Department of Energy
National Nuclear Security Administration

Thank you for your cooperation while we worked to resolve the issues raised by your staff regarding the design of safety-related aspects in the Tritium Extraction Facility (TEF) undergoing construction at the Savannah River Site (SRS). The Department appreciates the objective views from the Defense Nuclear Facilities Safety Board (DNFSB) on this subject and, likewise, is very interested in improving/adding design features to enhance the safety of the TEF. The enclosed responses have been discussed with your staff to reach a consensus on the issues. Formal concurrence with the Department's responses to the issues is requested to properly document the project's path forward with regard to this matter.

DNFSB ISSUES/RESPONSES (U)

Detailed Response to DNFSB Staff Issues and Observations

FIGURE 1

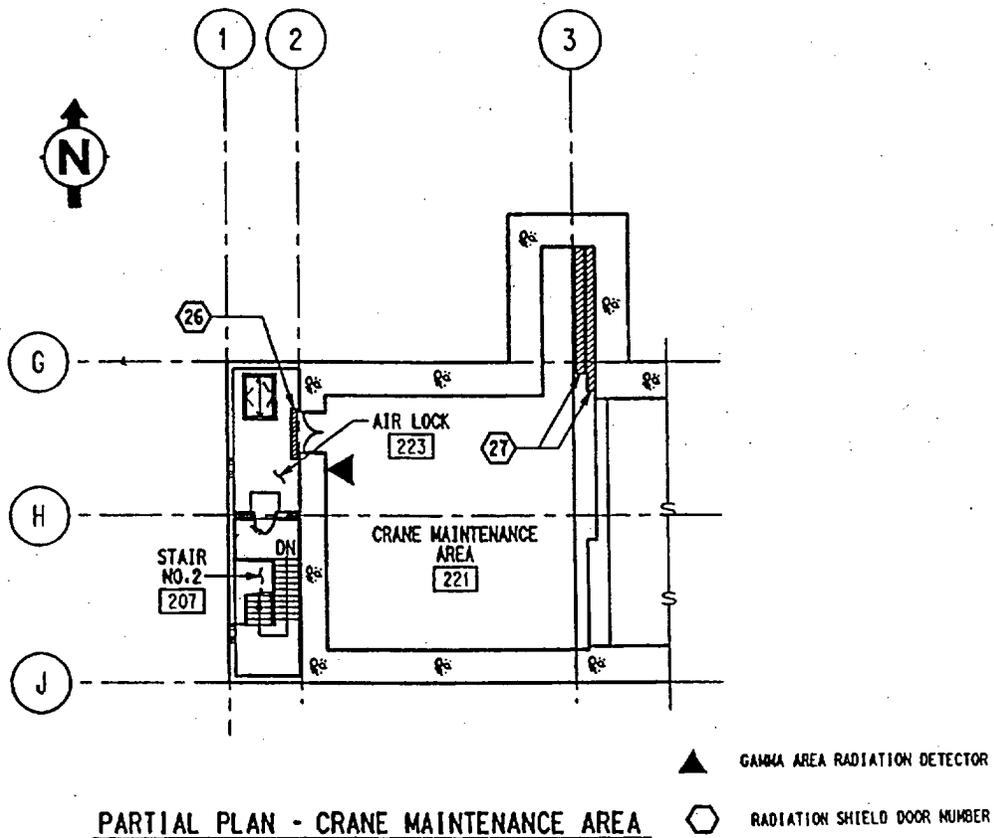
The design process hazards review identified a potential for exposure of workers to high levels of radiation if the shield doors should be inadvertently opened when cask or truck bay areas are occupied. Identification of radiation monitors and alarms to protect the workers was recommended. The control identified in the PSAR is limited to operator training and does not include implementation of any design features to protect workers.

Permanently installed, Safety Significant, area gamma radiation monitors are provided in the Remote Handling Building (RHB) at entrances into the Remote Handling Area (RHA). Permanent gamma radiation monitors are not provided in the RHA, due to the limited personnel access requirements and personnel exposures necessary to maintain and calibrate the detectors.

1. RE-3, Located on the north side of the dressout area. Refer to Figure 1 and reference 3.

2. RE-5 Located on the outside of the north side of the penetration air hood room wall. Refer to Figure 1 and reference 3.
3. RE-1 Located on the east side of the truck bay. Refer to Figure 3 and reference 3.
4. RE-6 Located on the outside of the north HEPA filter room wall. Refer to Figure 3 and reference 3.
